**FIGURE 1 – 408.5.3 Item 3
MULTILEVEL RESIDENTIAL HOUSING WITHOUT
VERTICAL OPENING ENCLOSURE**

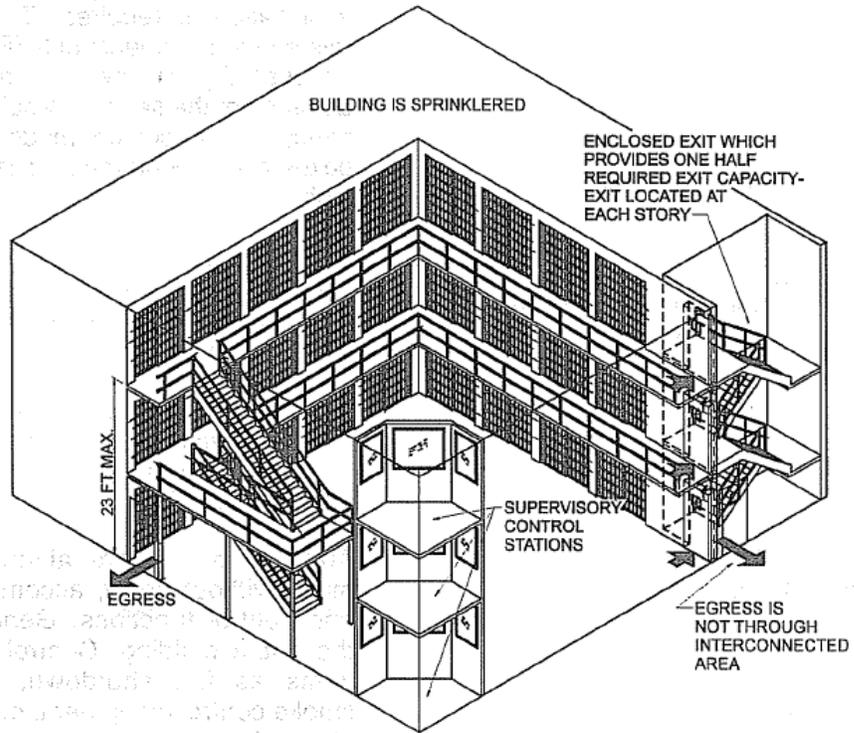
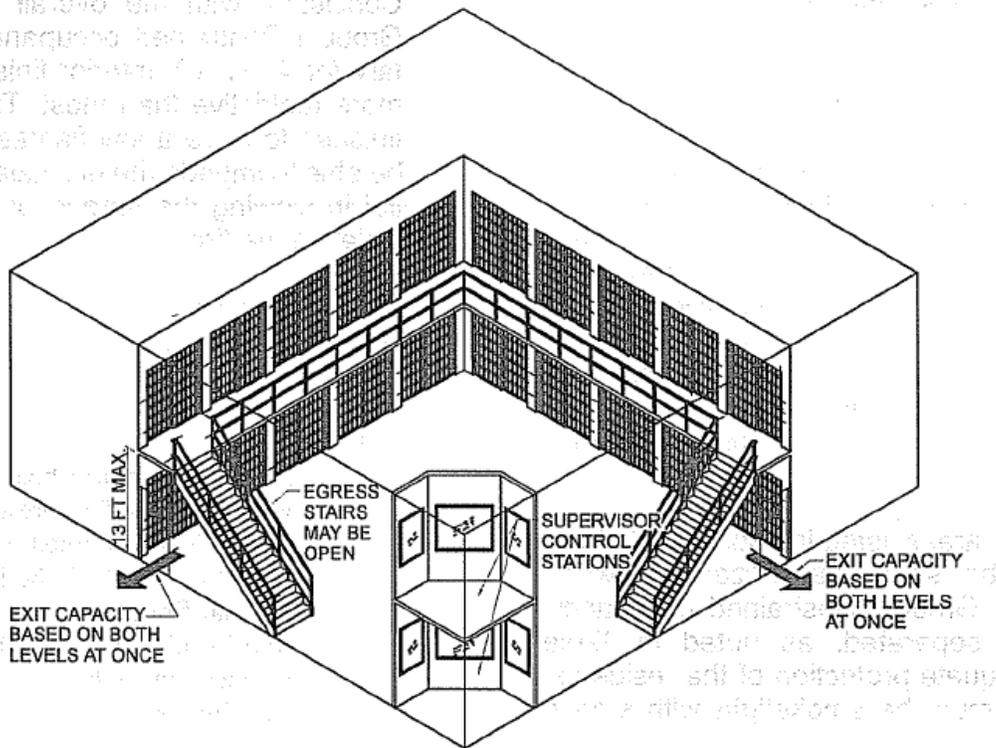
Reason: This change is intended to clarify the exiting from floor levels within the residential housing units. Without this change the "floor levels" get treated as stories and additional exits are required. Currently a residential housing unit with two floor levels and a very small occupant load can be required to have three exits which in a detention facility is problematic. This change would then allow the two level units to have just two exits with no direct egress from the upper floor level as long as common path and travel distances are met. The figures below illustrate the proposal and should be included in the commentary.
